City of Phoenix
PLANNING AND DEVELOPMENT DEPARTMENT

Staff Report: Z-74-18-2 / Z-76-18-2
December 28, 2018
REVISED

Desert View Village Planning Committee Meeting Date	January 8, 2019
Planning Commission Hearing Date	February 7, 2019
Request From (Z-74-18):	R1-6 DVAO (6.61 acres)
Request To (Z-74-18):	C-O/G-O DVAO (6.61 acres)
Request From (Z-76-18):	R1-6 DVAO (Pending C-O/G-O DVAO) (6.61 acres)
Request To (Z-76-18):	C-O/G-O DVAO HGT/WVR (6.61 acres)
Proposed Use	Rezone site to C-O/G-O DVAO with a height waiver up to 38 feet for development of a two-story office
Location	Southwest corner of Cave Creek Dam Road and Desert Peak Parkway alignment
Owner	Patrick Brown, DR Horton, Inc
Applicant/Representative	Jason Morris, Withey Morris, PLC
Staff Recommendation	Approval, subject to stipulations

Source: Strand Architects

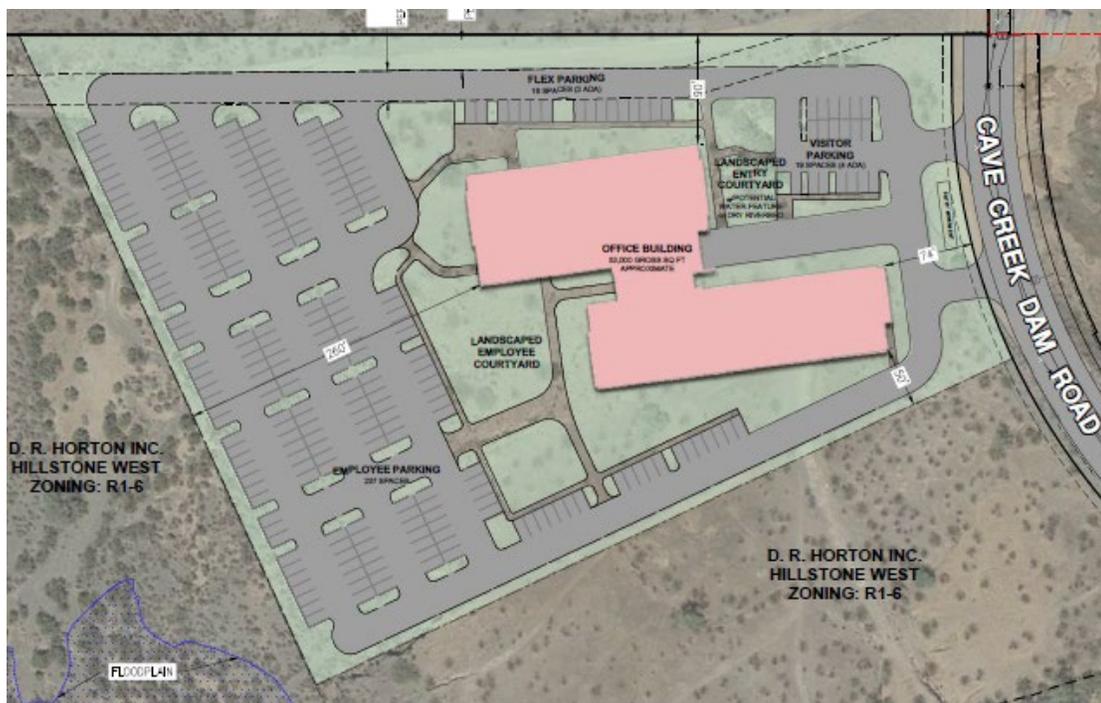
- The applicant has submitted proposed elevations for office development. The elevations show mass articulation and visual interest. To ensure the quality of the elevations proposed, staff has stipulated to general conformance to the elevations. This can be found in Stipulation No. 1 for both cases.

While providing articulation and visual interest, the bright white paint color shown on the conceptual elevations and aluminum materials proposed are not compatible with the surrounding natural desert. To ensure the development provides a cohesive transition from the natural desert to the built environment, staff is proposing Stipulations Nos. 2, 6, 7 and 8 for Z-74-18 and Stipulation Nos. 3, 7 and 8 for Z-76-18.

2. The color and material palette for the buildings shall be determined at site plan review and shall be muted and blend with, rather than contrast strongly or be reflective, with the surrounding desert environment, as approved by the Planning and Development Department.

7. The glazing on all building windows shall have a maximum reflectivity of 20%, as approved by the Planning and Development Department.
8. The developer shall construct all streets adjacent to the development with paving, curb, gutter, sidewalk, curb ramps, streetlights, landscaping and other incidentals as per plans approved by the Planning and Development Department. All improvements shall comply with all ADA accessibility standards.

2. The maximum building height shall be 38 feet.
3. The color and material palette for the buildings shall be determined at site plan review and shall be muted and blend with, rather than contrast strongly or be reflective, with the surrounding desert environment, as approved by the Planning and Development Department.

8. The glazing on all building windows shall have a maximum reflectivity of 20%, as approved by the Planning and Development Department.

HILLSTONE WEST
PHOENIX, AZ
SITE PLAN

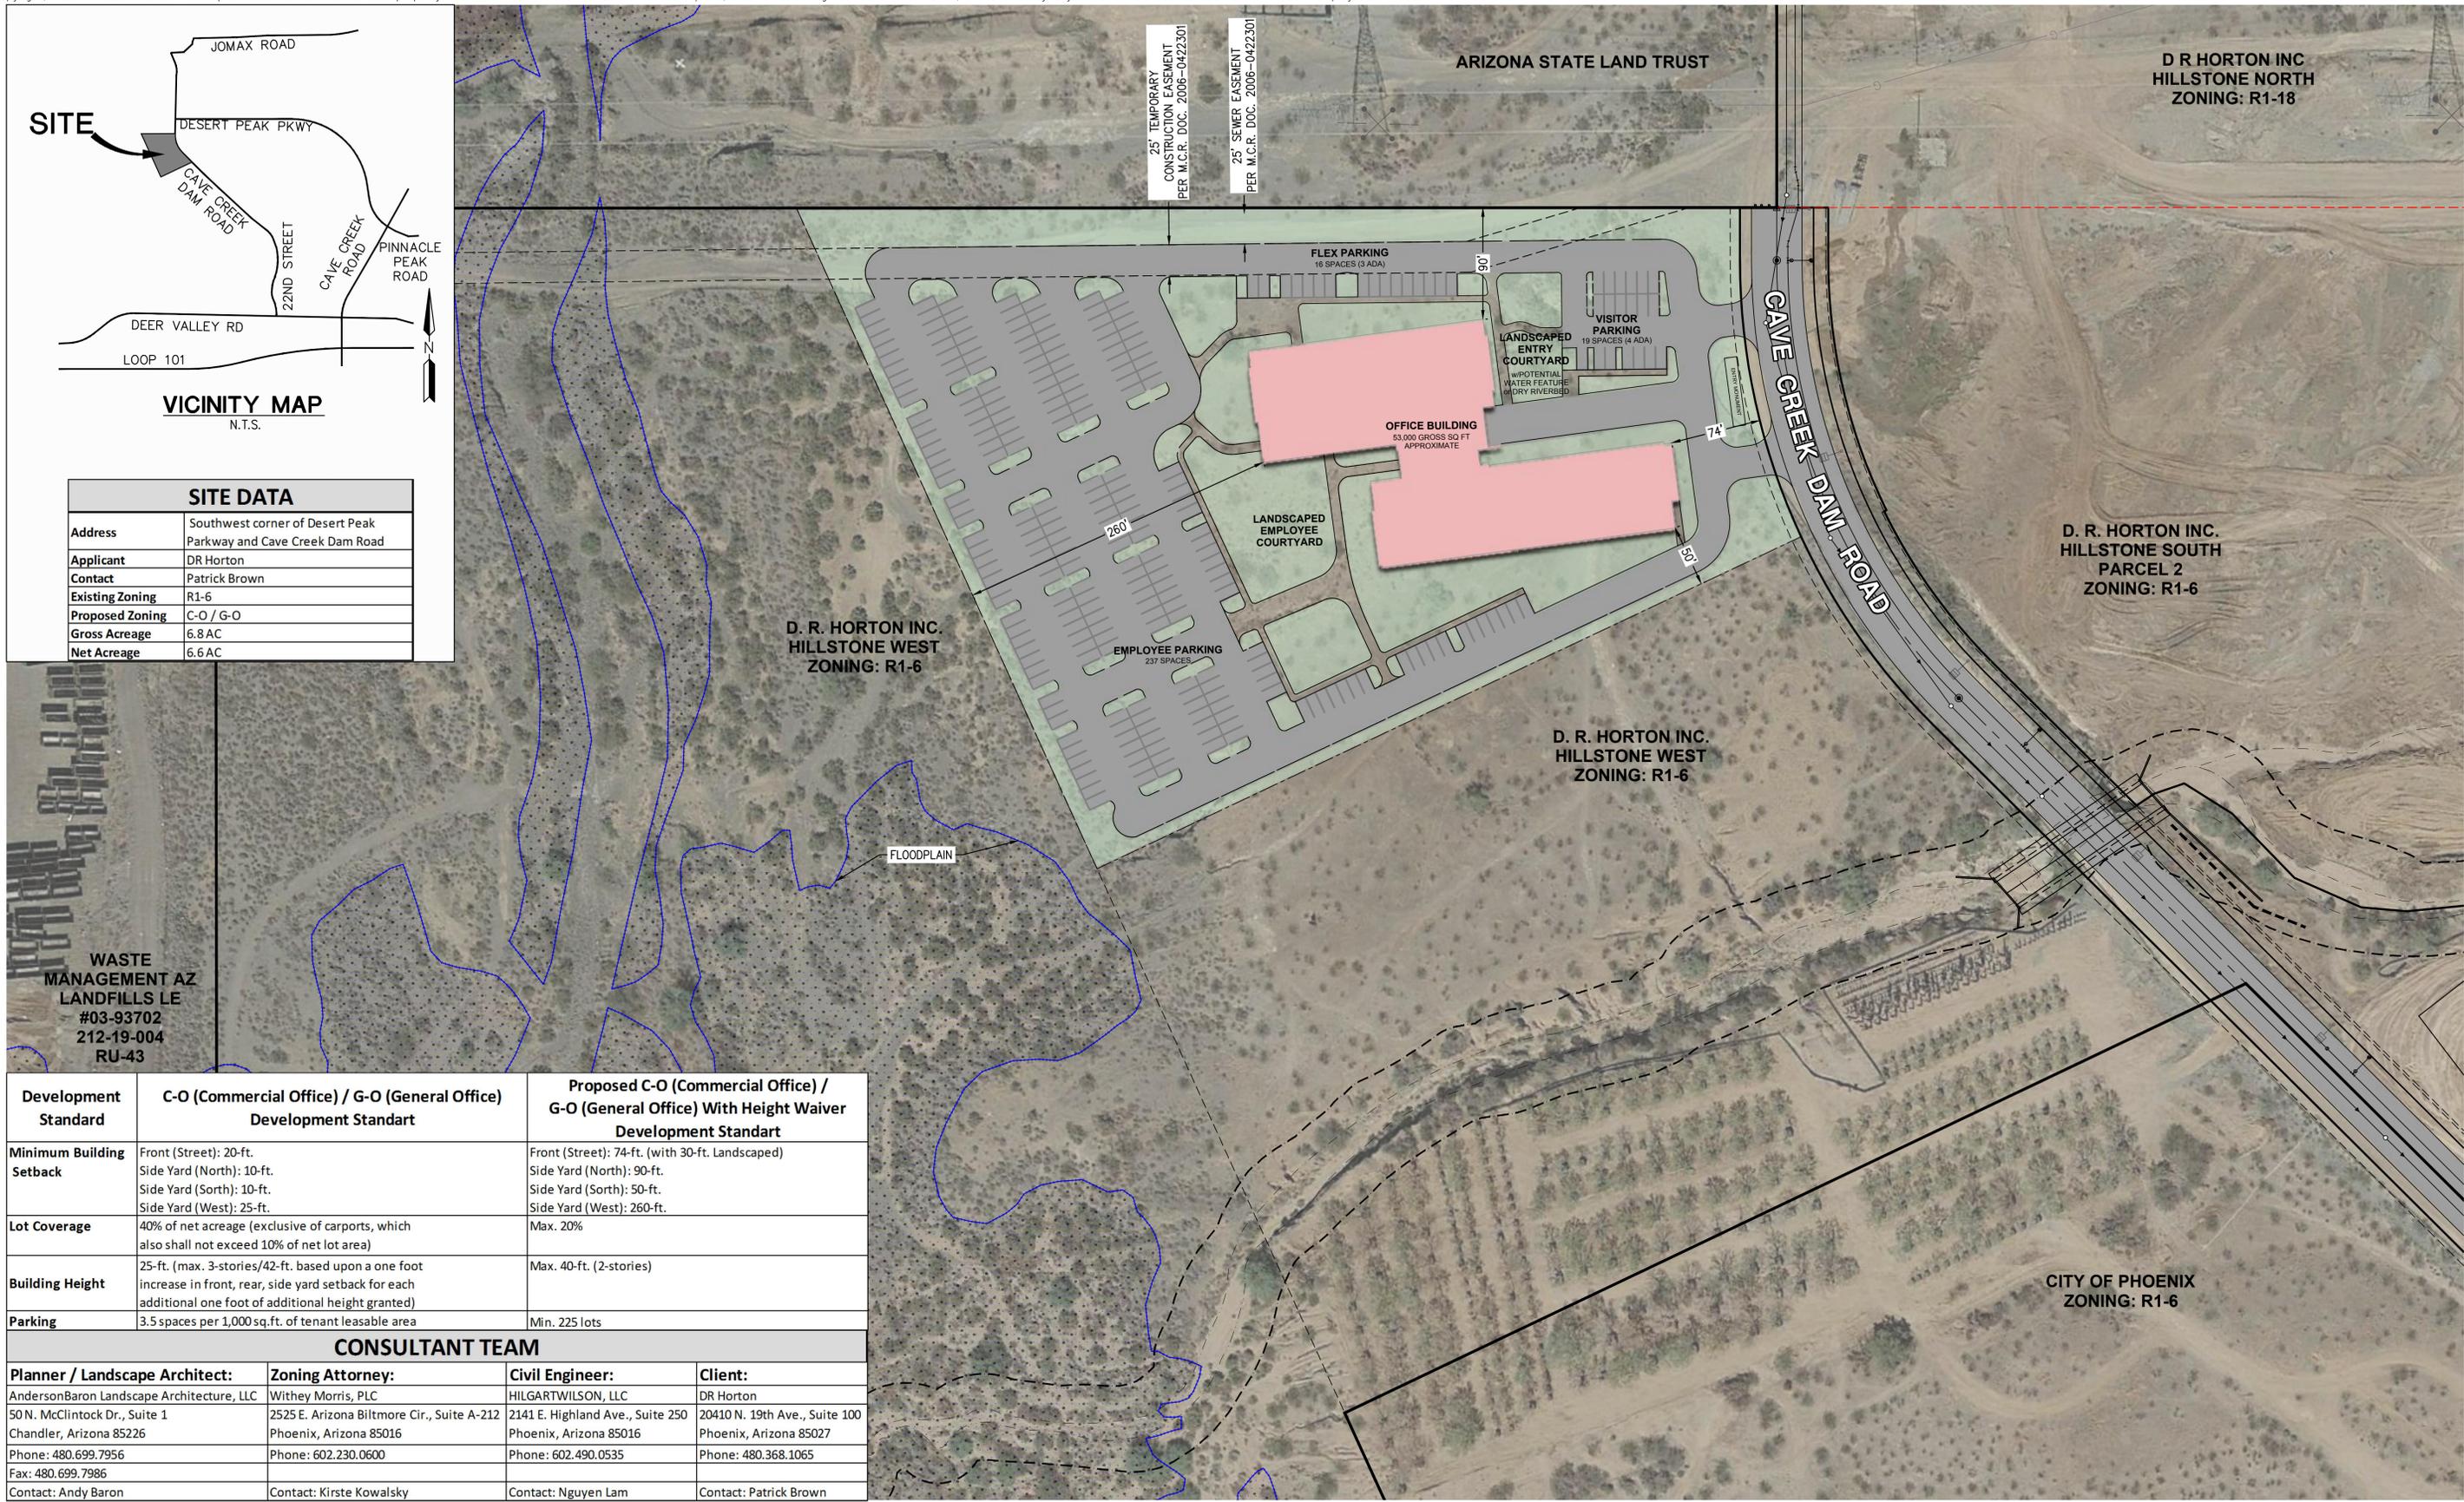
8. The site plan submitted depicts a substantial amount of parking with minimal landscape setbacks to the south and west. Staff is recommending a stipulation that required a minimum landscape of 25 feet adjacent to residential zoning districts. Given the proposed height waiver, the additional setback will provide an adequate buffer from the proposed office building to any future residential. This can be found in Stipulation No. 3 for Z-74-18-2 and No. 4 for Z-76-18-2.

The proposed site plan shows 225 parking spaces when 186 spaces are required. To ensure the parking lot is adequately shaded, staff is proposing Stipulation No. 4 for Z-74-18-2 and No. 5 for Z-76-18-2 that would require the development to comply with the C-2 standards, with the exception that a landscape island be provided every 8 parking spaces. The current Zoning Ordinance requirement is every 110 feet, which would equate to a landscape island every 10 to 11 feet.

3. A minimum landscape setback of 25 feet shall be required along property lines adjacent to residential zoning districts, as approved by the Planning and Development Department.

4. All parking lot landscaping requirements shall comply with the C-2 standards with the exception that there shall be 1 island every 8 parking spaces at a minimum width of 8-feet, as approved by the Planning and Development Department.

4. A minimum landscape setback of 25 feet shall be required along property lines adjacent to residential zoning districts, as approved by the Planning and Development Department.

5. All parking lot landscaping requirements shall comply with the C-2 standards with the exception that there shall be 1 island every 8 parking spaces at a minimum width of 8-feet, as approved by the Planning and Development Department.
